Project	<b>IEEE 802.16 Broadband Wireless Access Working Group</b> < <a href="http://ieee802.org/16">http://ieee802.org/16</a> >	
Title	<b>Enhancements to Dynamic Medium Acquisition</b>	
Date Submitted	<b>2008-03-18</b>	
Source(s)	Paul Piggin NextWave Wireless Unit 7 Greenways Business Park Bellinger Close Chippenham, Wiltshire SN15 1BN, UK.	Voice: 44 1249 800 100 Fax: 44 1249 800 101 ppiggin @ nextwave.com
Re:	Letter Ballot #29a of IEEE P802.16h/D4.	
Abstract	To date LBT (Listen Before Talk) as realized by the DMA (Dynamic Medium Acquisition) algorithm provided coexistence between 802.16h and 802.11y. The contribution details enhancements to the DMA algorithm that provides 802.16h to 802.16h coexistence, in addition to 802.16h to 802.11y coexistence.	
Purpose	Refine the definition of LBT (Listen Before Talk) and DMA (Dynamic Medium Acquisition) in IEEE P802.16h/D4 based on the latest simulation results.

# Enhancements to Dynamic Medium Acquisition

Figure h200803-01 – A detailed example of 2 802.16 and 1 802.11 systems sharing the medium.

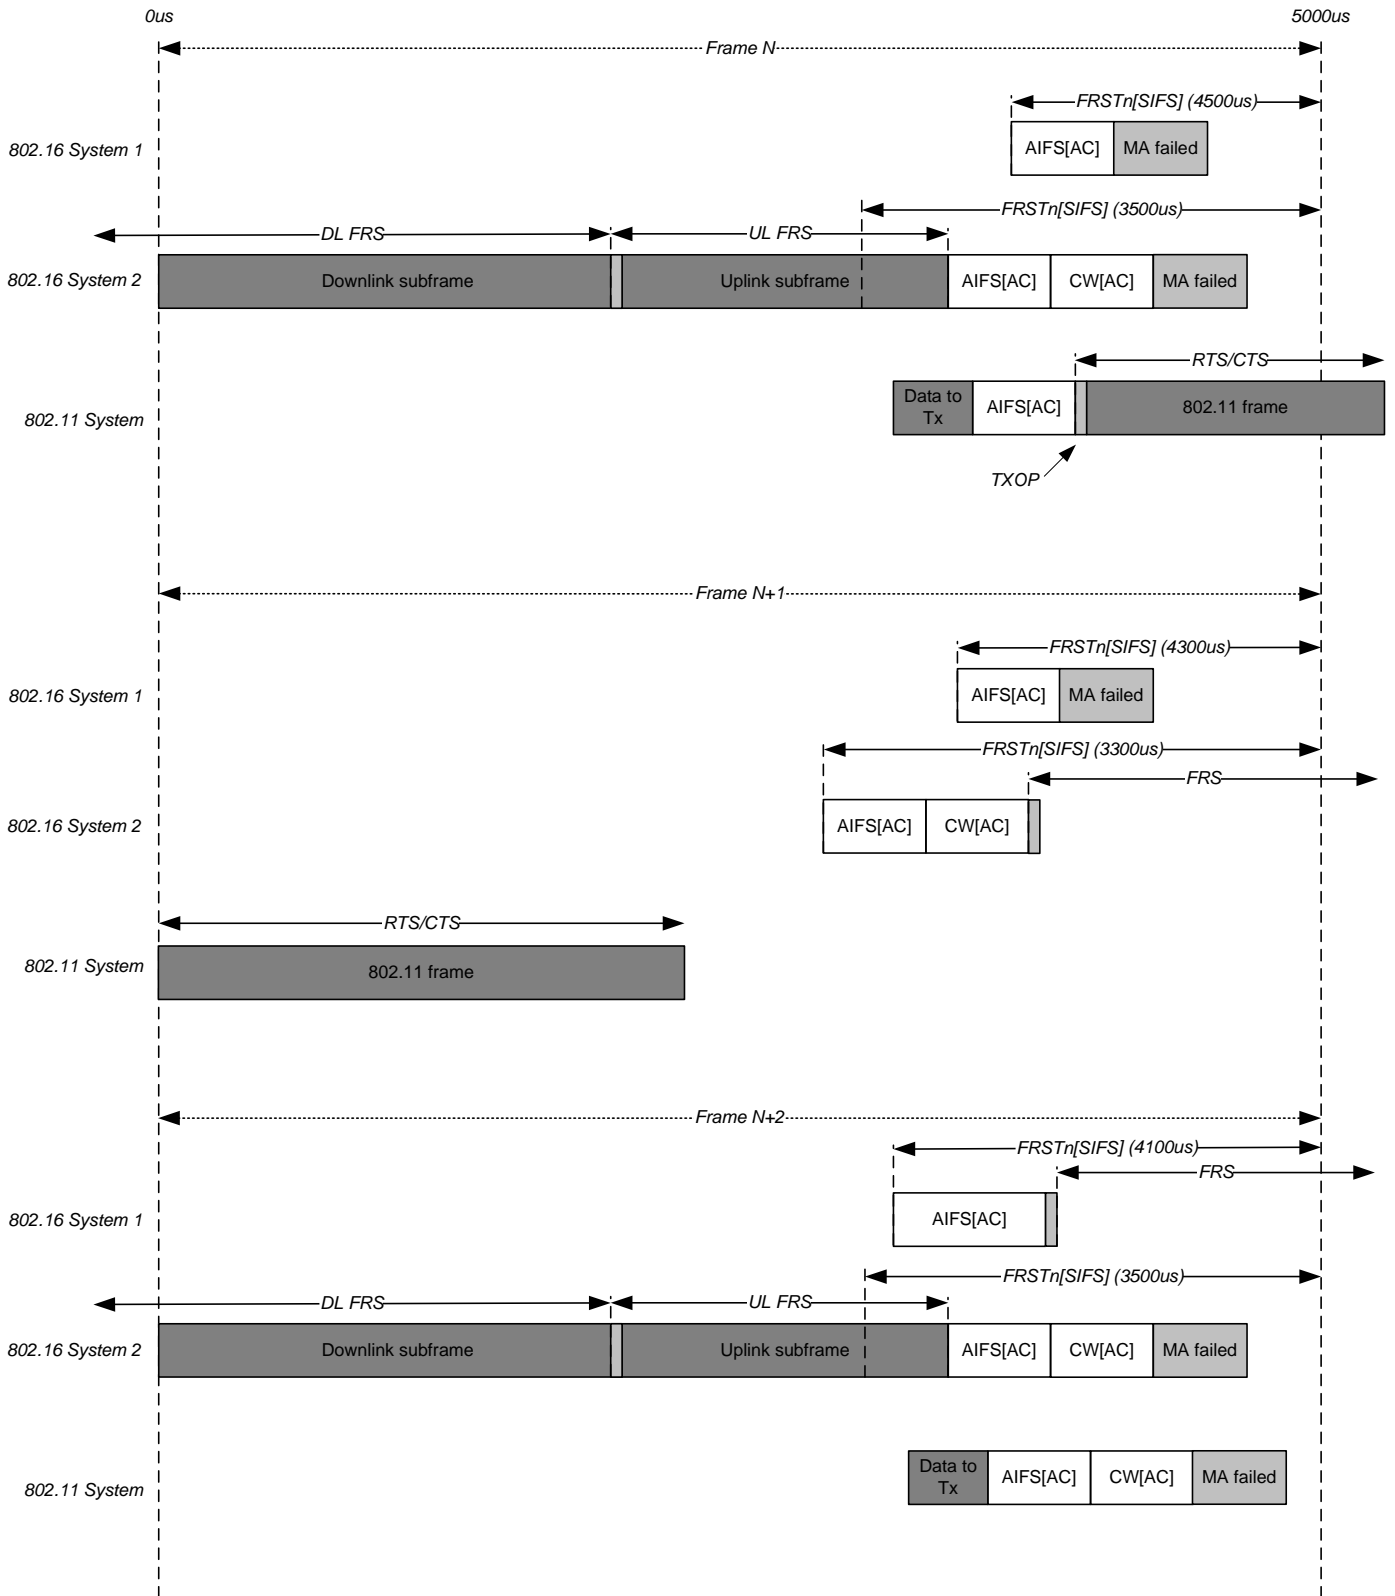
An example of the usage of the DMA discovery protocol is given in figures h200803-01.
